# Access Compliance Report

## Public Rights-of-Way

### (Curb Ramps)

Intersection ID: 22902	Main Street: CARMEL_RD	Cross Street: MOORLAND_DR	Location: NE
ADA ID: B618BA665CB6	Ramp Type: PerpDiag	Initial Pass/Fail: Fail	Overall Compliance: No
		Severity Score: 12.5

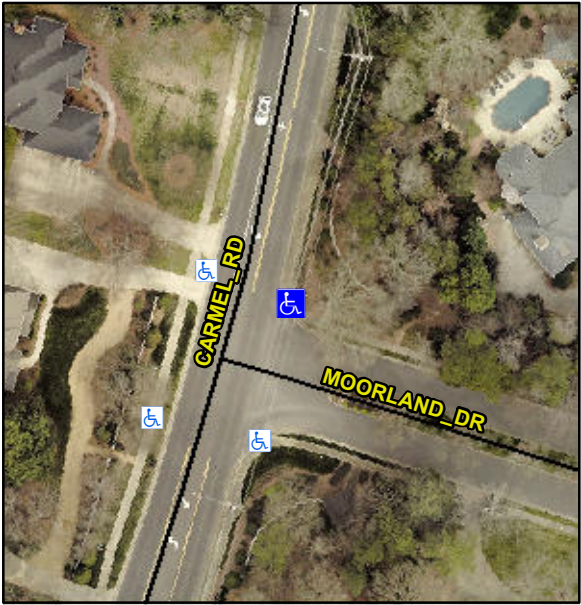
Codes/Mitigation Info/Possible Solution			Field Measurements/Component Compliance		
	Possible Solutions:		<b>Compliance</b>	<b>Description</b>	<b>Data</b>
	<b>Remove &amp; Replace Curb Ramp With Two New Directional Ramps or Equivalent.</b>		N/A	Ramp Length (in)	69.0
			Yes	Ramp Width (in)	48.0
			N/A	Flare Type LT	N/A
			N/A	Flare Slope LT (%)	N/A
			N/A	Flare Traversable LT?	N/A
			N/A	Landing Length (in)	N/A
			N/A	Landing Width (in)	N/A
			N/A	Landing Slope (%)	N/A
			N/A	Landing X Slope (%)	N/A
			N/A	Landing Curb? (Y/N)	N/A
			N/A	Shared Landing?	N/A
			N/A	Gutter Ponding?	N/A
			N/A	Gutter Lip Ht (in)	N/A
			N/A	Painted X Walk1?	No
				X Walk 1 Direction	To NW
			N/A	X Walk 1 Width (in)	N/A
				X Walk 1 Slope (%)	0.0
				X Walk 1 X Slope (%)	0.8
			N/A	Ramp inside XWalk1?	N/A
<p>Surveyor Notes:</p> <p><b>N/A</b></p> <p>PROW/ADA:</p> <p><b>Not Found, R304.2.2</b></p>			N/A	Flare Type RT	N/A
			N/A	Flare Slope RT (%)	N/A
